Manual Update Sheet

Document Being Updated: *TMS320LF/LC240xA DSP Controllers Reference Guide: System and Peripherals*

Literature Number Being Updated: SPRU357B

This Manual Update Sheet (literature number SPRZ015C) ships with the *TMS320LF/LC240xA DSP Controllers Reference Guide: System and Peripherals* (literature number SPRU357B).

Figure 5-1, Shared Pin Configuration

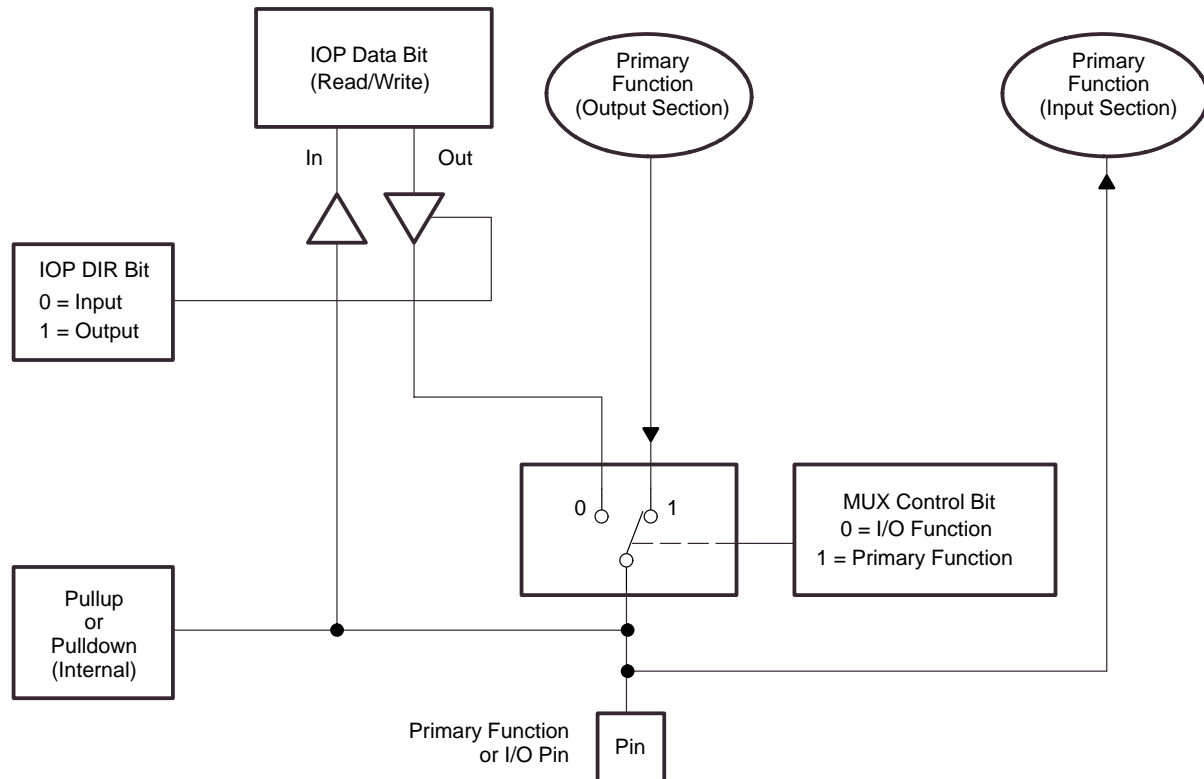
Replace the current drawing with the following:

Figure 6-33, Quadrature Encoder Pulse (QEP) Circuit Block Diagram for EVA

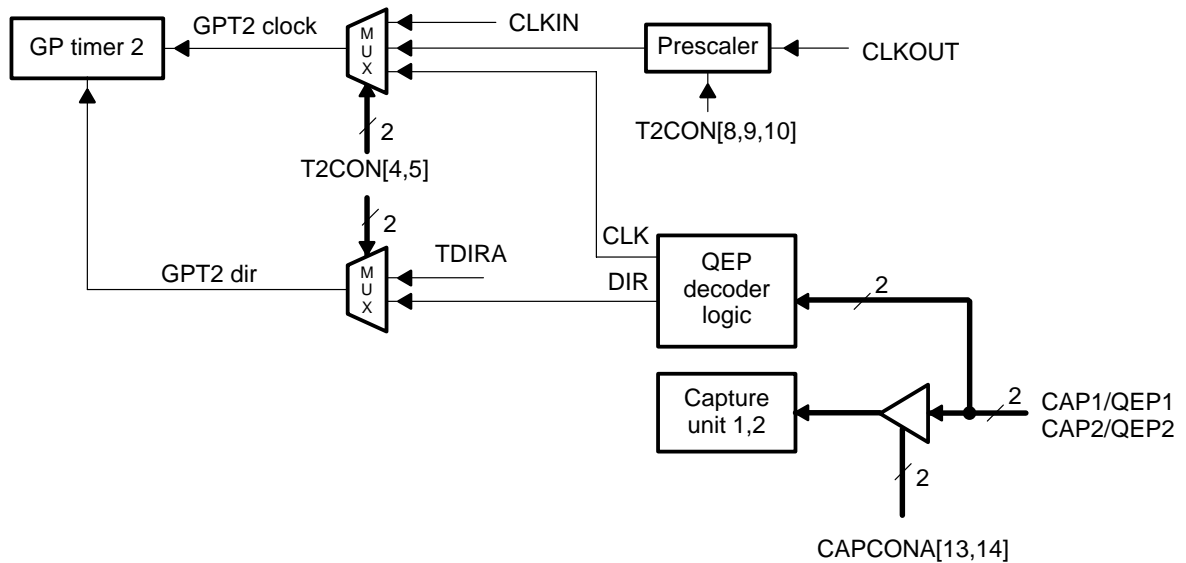
Replace the existing figure with the following:

Figure 6-34, Quadrature Encoder Pulse (QEP) Circuit Block Diagram for EVB

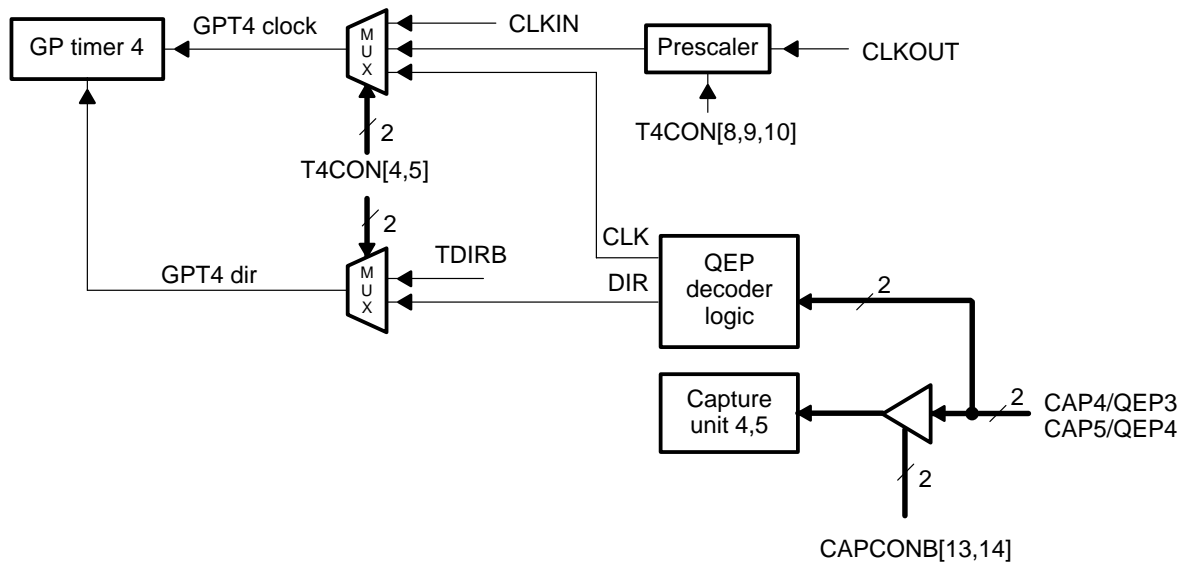
Replace the existing figure with the following:
